**PLANNING AND DEVELOPMENT SERVICES STAFF REPORT**

**For Planning Commission Meeting of March 6, 2012**

**SUBJECT: Shell Service Station/Convenience Store Revised PUD Zoning and Supplemental Regulations, and PUD Site Plan  
(2679 Ann Arbor-Saline Road)  
File No. Z12-001 & SP12-001**

**ENLARGED SITE PLAN**

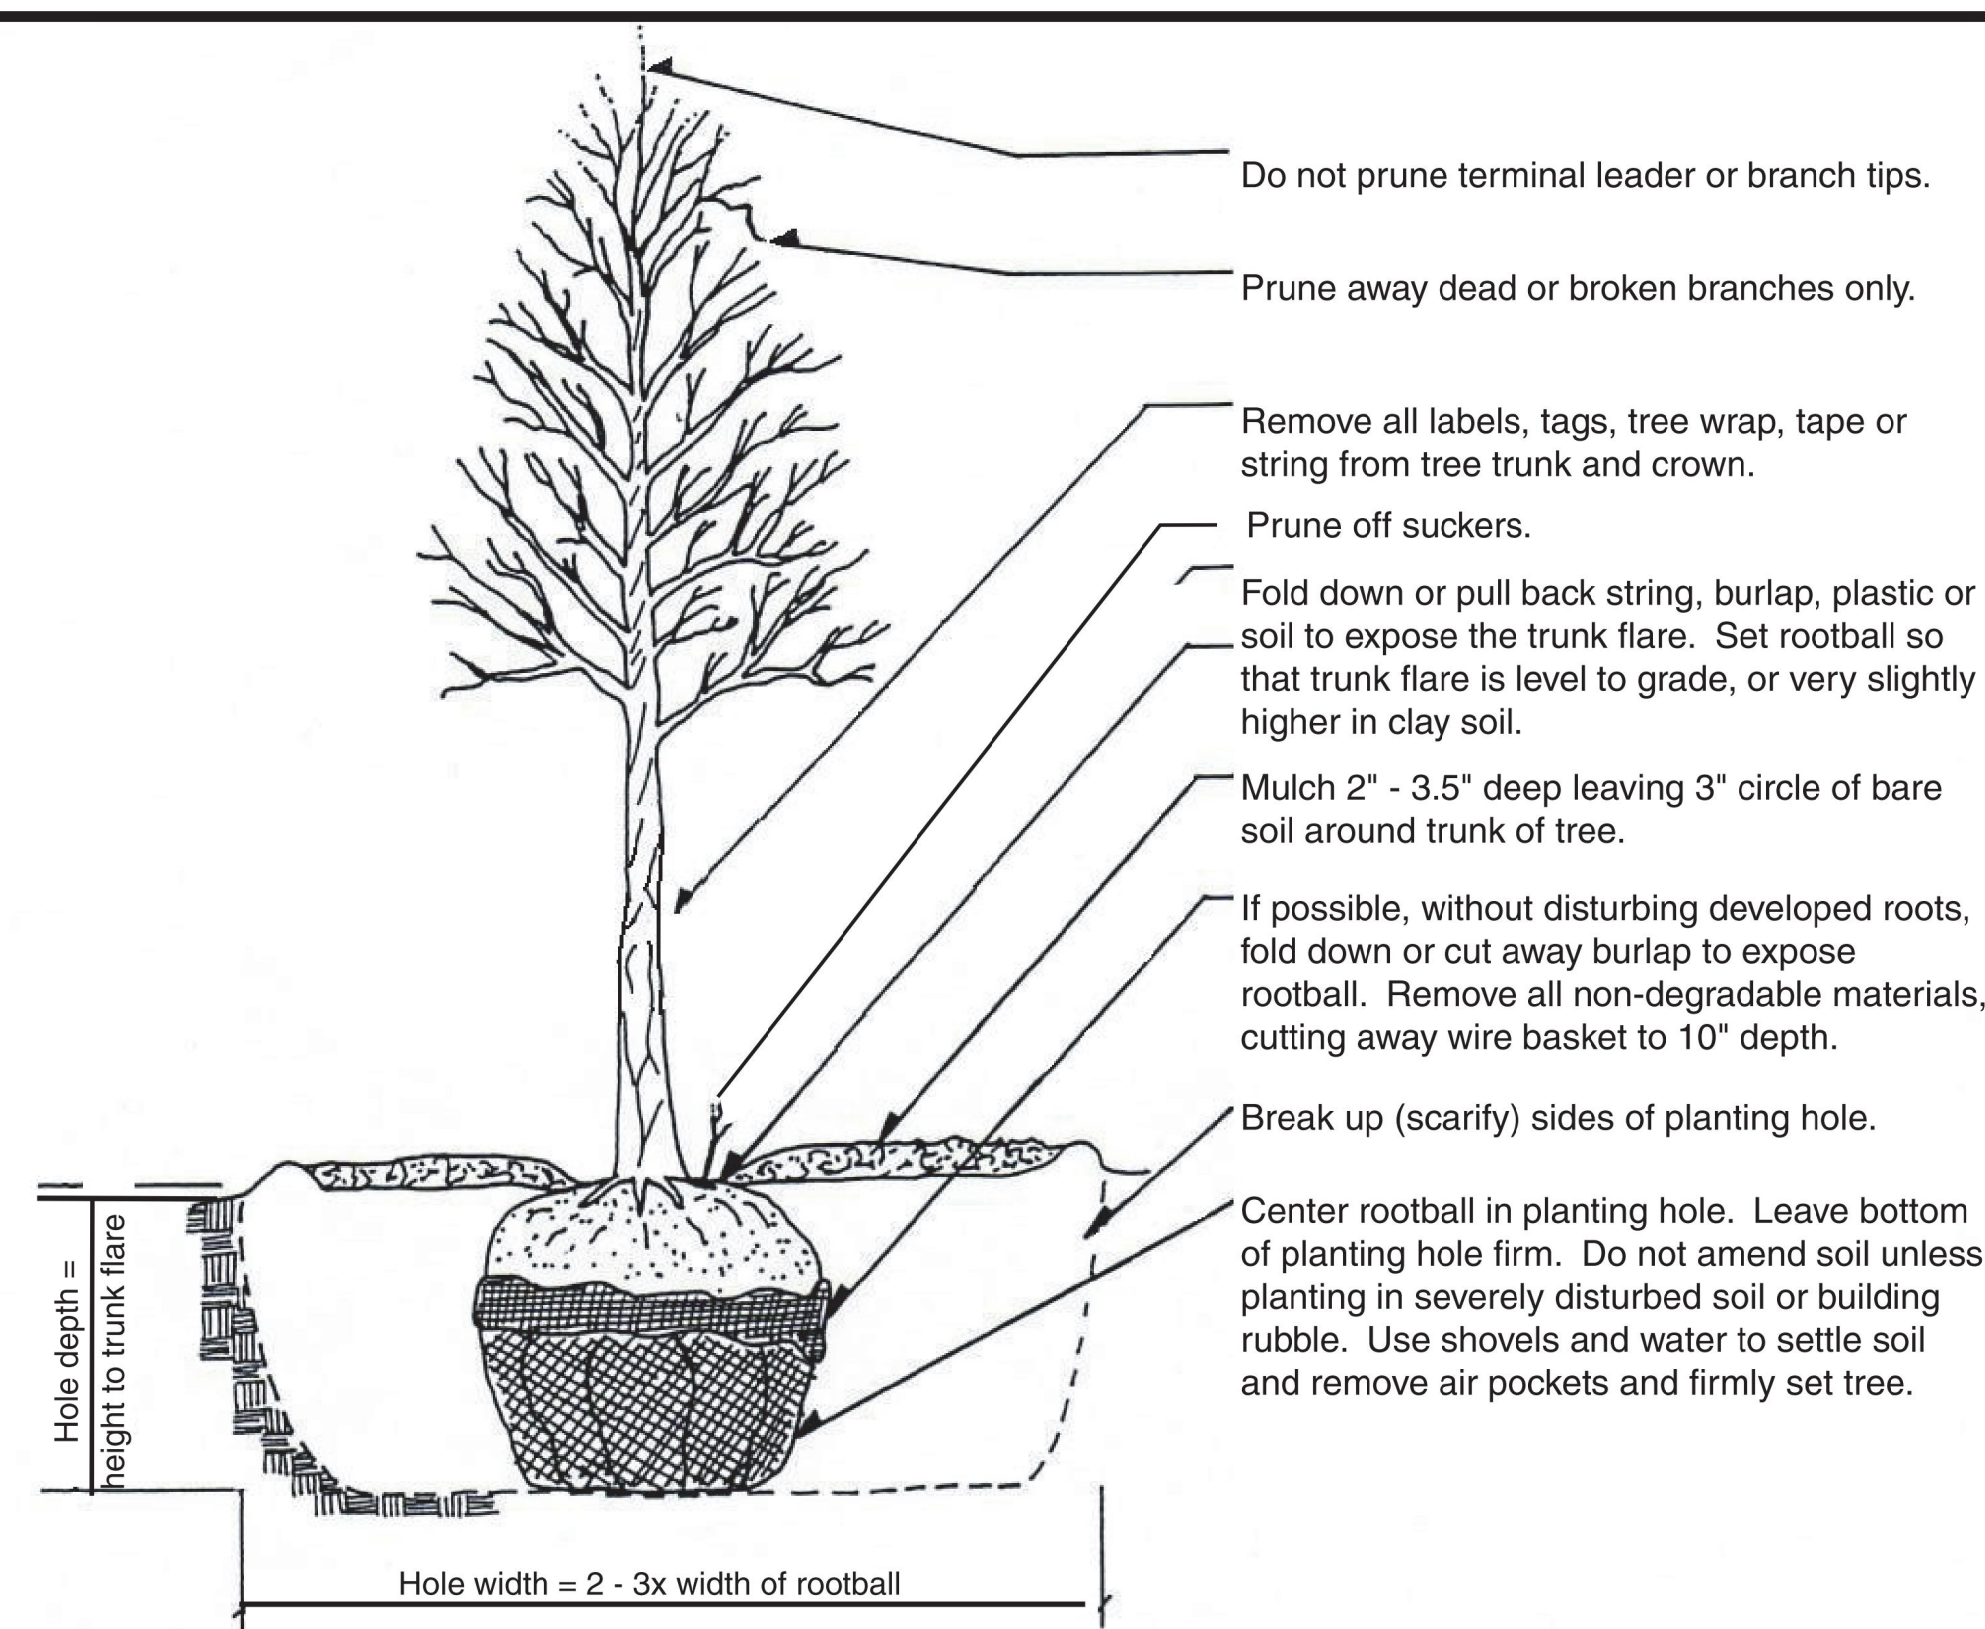
Traffic – A trip generation evaluation and a statement on the impact to the adjacent intersection is needed.

Systems Planning - A *City of Ann Arbor Geodetic Reference System (AAGRS) Coordinate Transformation Worksheet* shall be submitted for review and approval at this time.

Sewer flow data comparing the proposed flow as a result of this project versus the existing flow shall be included on the plans for evaluation. If the proposed flows are greater than the existing flows, the increased flow must be mitigated.

Development Services – Revised storm water detention calculations based on 1.44 acres are required.

The driveway connection to running east to Cranbrook Village Shopping Center does not appear feasible due to significant grade change between parcels. Staff is working with the petitioner on the status of this connection. If viable, an administrative amendment to the shopping center site plan will be required.
